SS 3102 FTL-2022 P4 with 100/120/130 Gallons Fuel Tanks interference/rubbing with fairing bracket.

Applies to all New Cascadia (P4) vehicles built with 100/120/130 Gallons Fuel Tanks.

Figure 1: Fuel Tank - Fairing Bracket Interference/Rubbing issues.

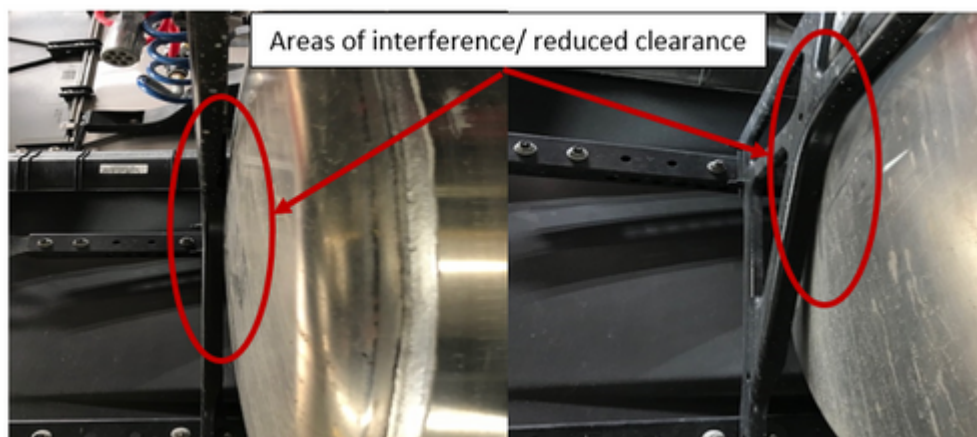
Fuel Tank installation may have reduced clearance with Fairing Brackets (LHS), mainly due to tolerance stacking. This reduced clearance causes interference/rubbing issues of Fuel Tanks with Fairing Brackets at low mileages that may cause Fuel leaks and require Fuel Tank replacement.

Figure 2: Reduced clearance at the Fairing Frame mounting Bracket area.

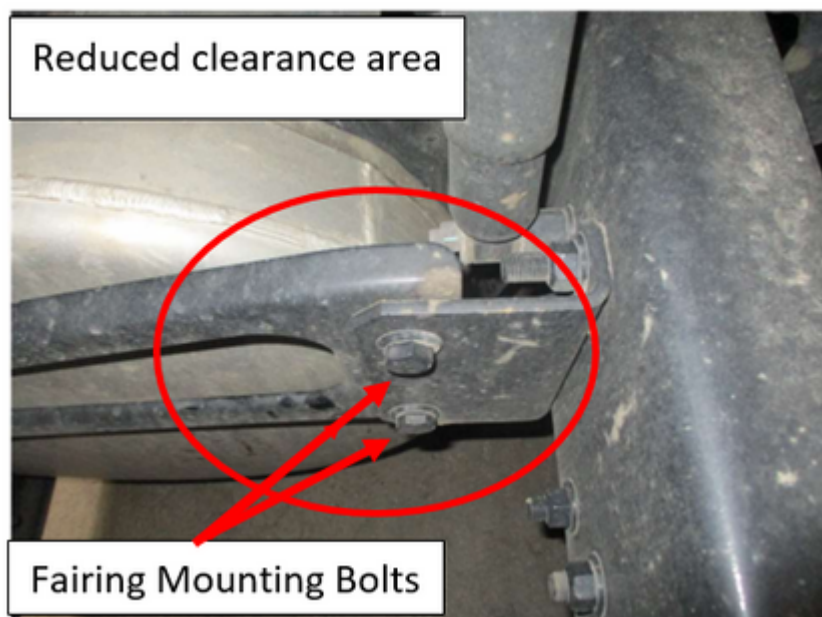
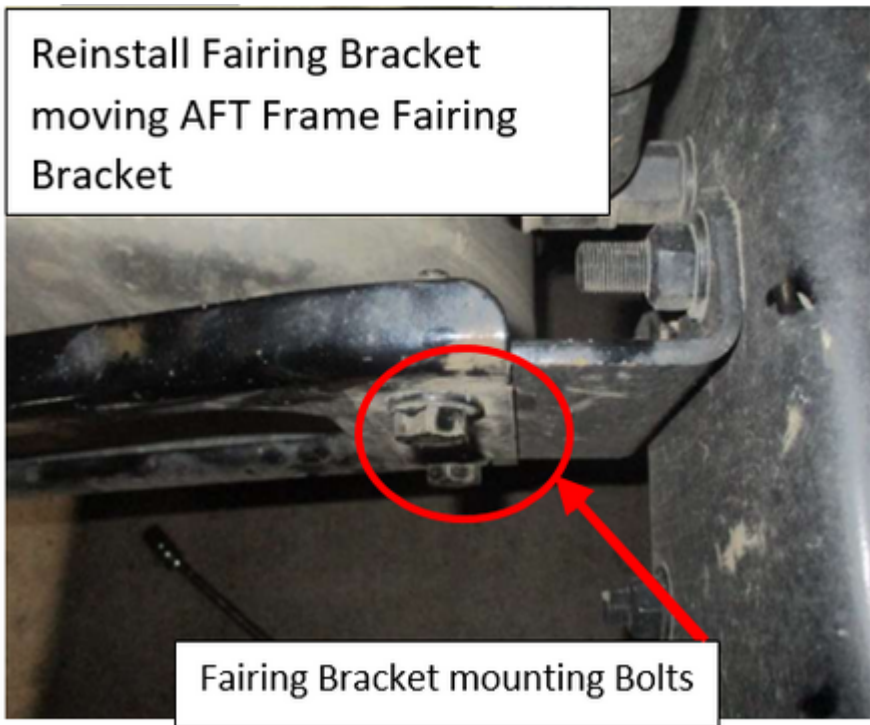
a) To increase clearance at the Frame mounted Fairing Bracket area shown in Figure2:

i. Remove Fairing Bracket mounting bolts and install Fairing Bracket as shown in Figure 3.

ii. Reinstall Fairing Bracket as shown in Figure 3 and torque mounting bolts to $235 (+/- 24) \text{N*m}$ ($174 (+/- 18) \text{Lbf*Ft}$).

Figure 4. Reduced Clearance/Interference at the Fairing Rail Bracket mounting area.

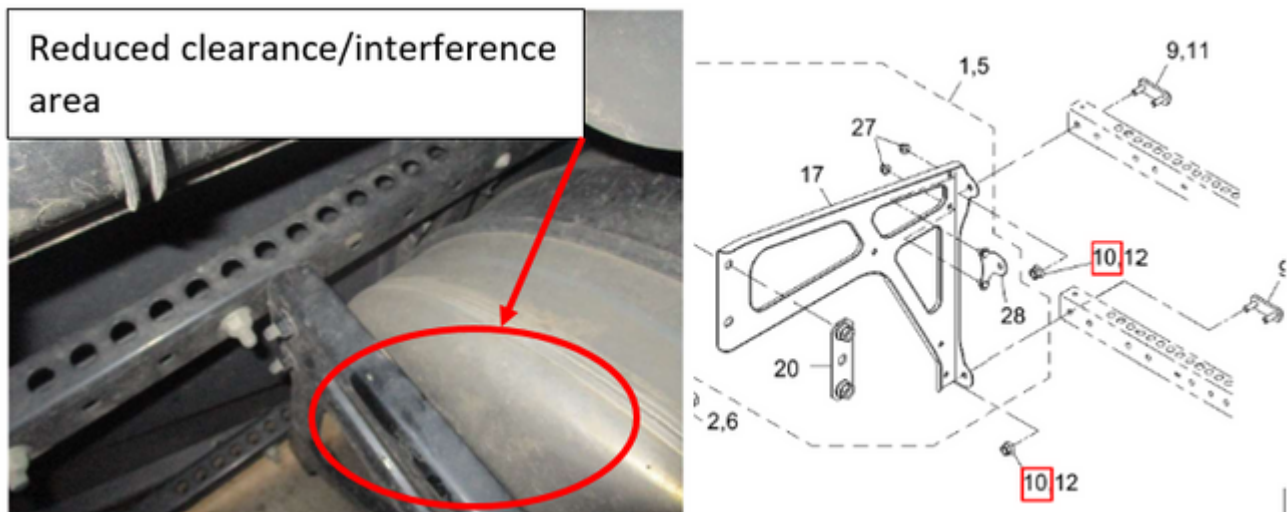
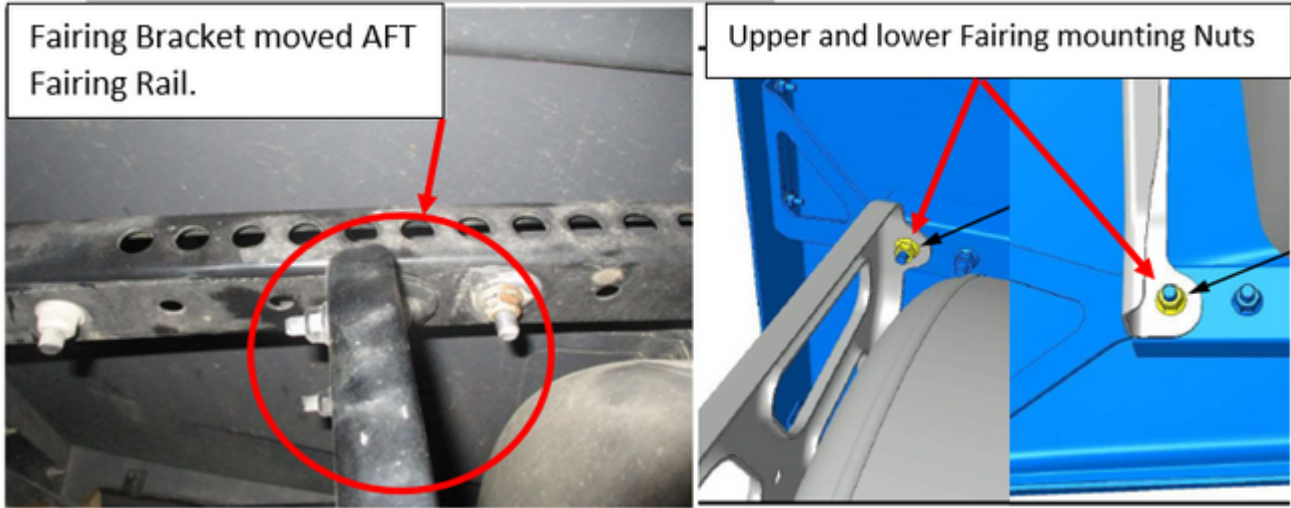
b) To increase clearance/interference at the Fairing Rail Bracket area, shown in Figure 4:

i. Remove Item 10 lower and upper mounting Nuts, and position the Fairing Bracket AFT in the Fairing Rail as shown in Figure 5. Reinstall Nuts, torque Nuts to 47 (+/- 5) N*m (35 (+/-4) Lb*Ft) and proceed to next step.

ii. Remove upper and lower Nuts Item10 from Fairing Rail and reinstall Fairing Bracket in its new position as shown in Figure 5, torque Nuts to 47 (+/- 5) N*m (35 (+/-4) Lb*Ft).

iii. Verify clearance between Fairing Bracket and Fuel Tank has been increased at both sides of the Fairing Bracket mounting.
